## Notice

FILE NO. C-2042

Category : Liquid Crystal Colour Video Projector

Model : PLC-220P/PB/PP

## COMPONENT AND TESTPOINT LOCATIONS TIMING & LC DRIVE BOARD (COMPONENT SIDE)

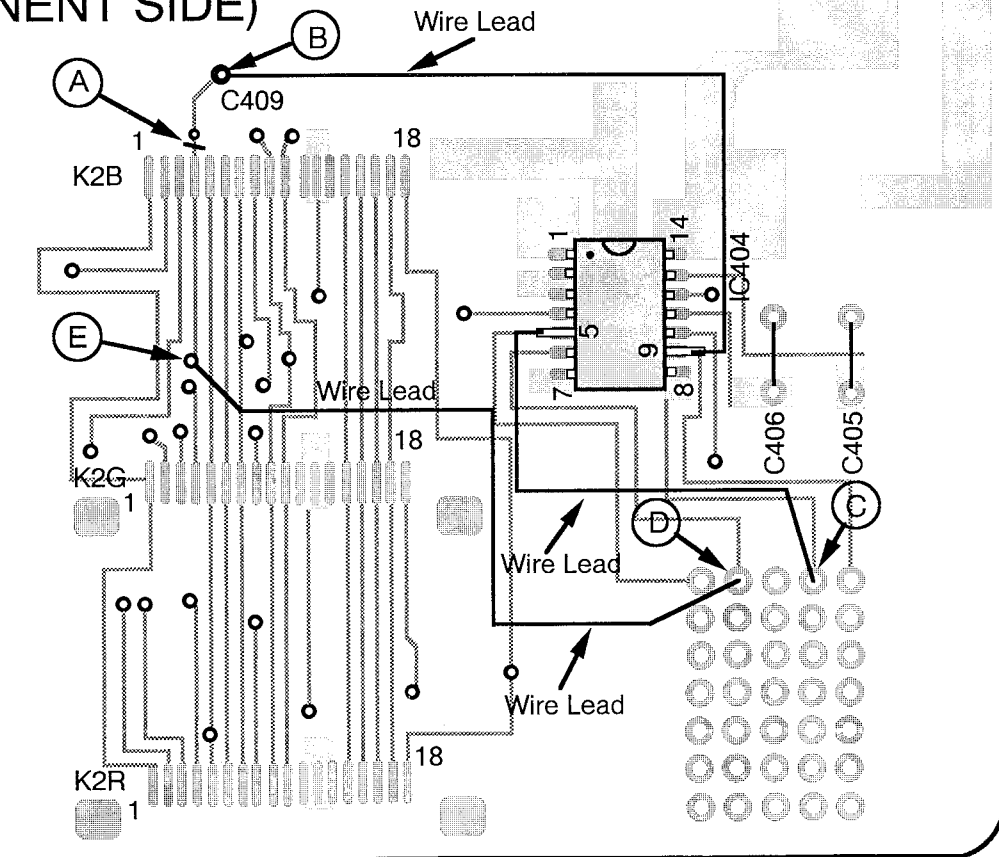
It is necessary to change the circuit when all three panels (R, G, B) are replaced for the projectors with serial numbers (The Serial No. is shown on the rating plate). listed in the table on the right. Follow the procedure described below to change the circuit.

1. Cut to foil at point A.
2. Take the No. 9 pin of the IC404 off from the foil, and solder it and point B with a wire lead.
3. Take the No. 5 pin of the IC404 off from the foil, and solder it and point C with a wire lead.
4. Solder the point D and E with a wire lead.
